**RESOLUTION SETTING HEARING ON REQUEST FROM HUBBELL REALTY COMPANY (OWNER), REPRESENTED BY CALEB SMITH (OFFICER), FOR REVIEW AND APPROVAL OF THE PUD FINAL DEVELOPMENT PLAN FOR “GRAY’S STATION PLAT 5 TOWNHOMES AND CLUBHOUSE,” FOR PROPERTY LOCATED IN THE VICINITY OF 1300 TUTTLE STREET TO ALLOW FOR CONSTRUCTION OF 65 TOWNHOMES AND A CLUBHOUSE AMENITY BUILDING**

Communication from the City Plan and Zoning Commission advising that at their February 2, 2023 meeting, the following action was taken regarding a request from Hubbell Realty Company (owner), represented by Caleb Smith (officer), for the following regarding property located in the vicinity of 1300 Tuttle Street:

Part B) Approval of the proposed PUD Final Development Plan "Gray's Station Telus Condos," subject to compliance with all administrative review comments, plus the following conditions:

Part C) Approval of the proposed PUD Final Development Plan "Gray's Station Plat 5 Townhomes and Clubhouse," subject to compliance with all administrative review comments, plus the following conditions:

NEW FRONT ELEVATION

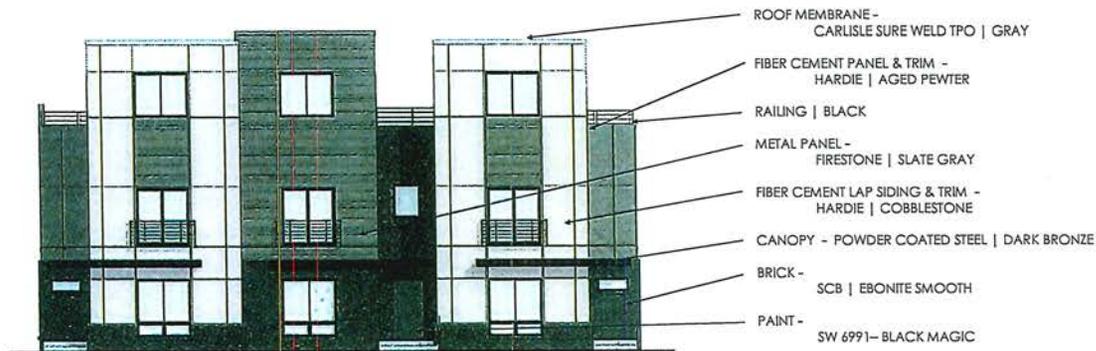
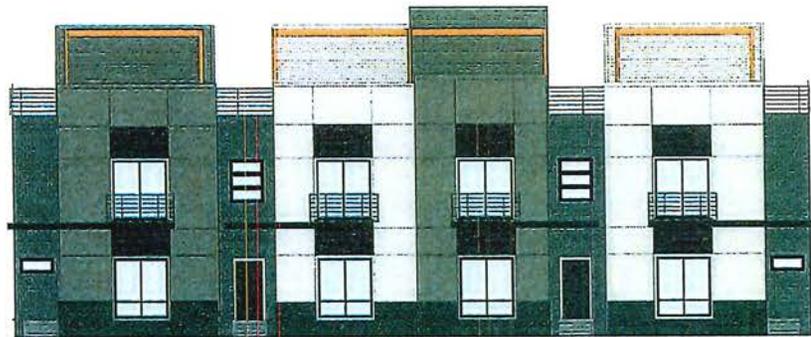
This elevation was too busy and the color scheme too light for this urban environment.
